December 9, 2010  
NRC3-10-0056

Subject: Updates to the Fermi 3 COLA Reflecting Incorporation of DCD Rev. 7 and 8 Changes to Standard Plant Site Parameter - Soil Properties Requirements

**Markup of the Fermi 3 COLA, Revision 2**

**Table 2.0-201 Evaluation of Site/Design Parameters and Characteristics (Sheet 7 of 28)**

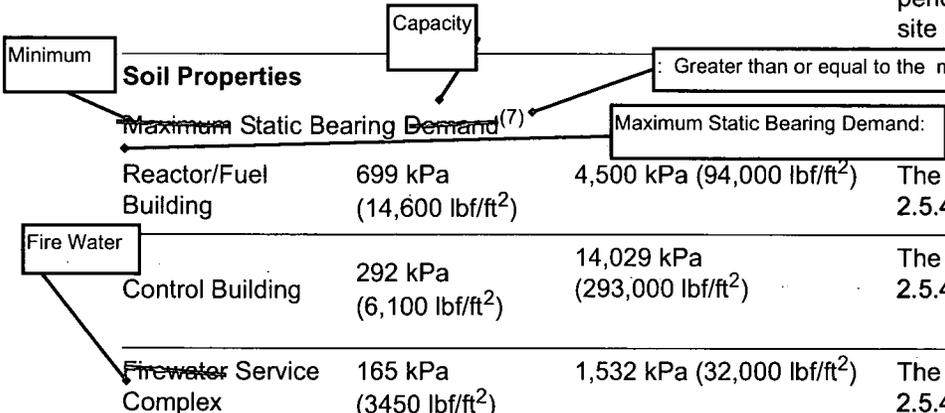
COLA Markup	Description of COLA Markup
FSAR Table 2.0-201	Revised minimum static/dynamic bearing demand to minimum static/dynamic bearing capacity, removed at rest pressure coefficient requirement, and updated soil density requirement to reflect DCD Revision 7 changes. Updated Notes 7 and 8 to reflect DCD Revision 7 and Revision 8 changes.
FSAR Section 2.5.4.5.4.2	Removed at rest pressure coefficient requirement and updated soil density requirement to reflect DCD Revision 7 changes. Added minimum shear wave velocity requirement. Added reference to new ITAAC for backfill adjacent to Category I structures.
FSAR Section 2.5.4.7.6	Revised the depth of engineered granular backfill due to the removal of the concrete plug requirement in DCD Revision 6.
FSAR Section 2.5.4.10	Revised dynamic bearing pressures for Reactor/Fuel Building, Control Building, and Firewater Service Complex to reflect DCD Revision 6 changes not made in FSAR Revision 2.
